Solicitation Number: 36C26322R0138

**Project Number: 568-14-110 Renovate and Consolidate Inpatient Functions for Building 113
Responses to Questions/RFI/Clarifications**

E5 CEILING @ CORRIDOR WDW
1 1/2" = 1'-0"

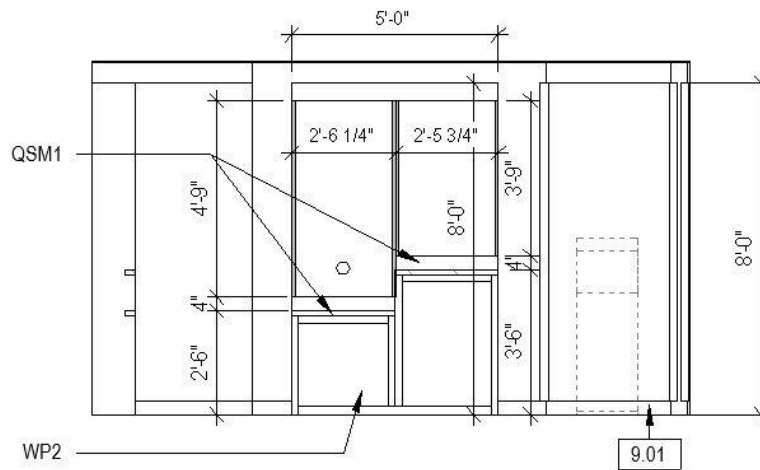
1. Is this project going to be tax exempt?
 - a. All applicable Federal, State, and local taxes shall be included in accordance with FAR 52.229-3.
2. Can the project superintendent also be the SSHO?
 - a. Yes
3. Can we change the bid date, so it doesn't land on a Monday?
 - a. See SF30 for bid date extension.
4. Do the new windows require precast lintels?
 - a. Windows requiring cut stone sill to match existing are shown on exterior elevations.
5. Will control joints work for patch back in brick or do we need to tooth the new brick back in?
 - a. No tooth in exterior brick.
6. Can the VA provide a better Detail E5 sheet AE505?
 - a. Revised detail E5 shown below.

E8 **SPEC CARE RECEIPT - FROM CORR**
 1/4" = 1'-0"

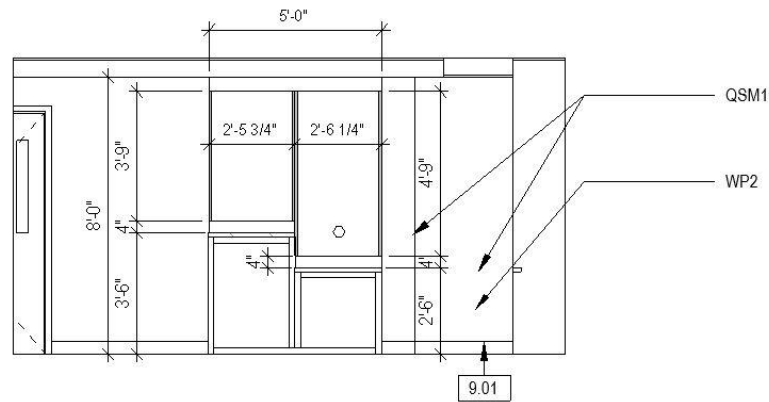
10. Sheet AE102 and sheet AE406 show (2) transaction windows at room 188A. However, they are not mentioned in a spec or given dimensions. Please confirm if they are in the scope of work and if so, please provide additional information on these windows (i.e. spec, basis of design, sizes, etc.)
 - a. See details with dimension below for aluminum frame and specialty transaction glazing.
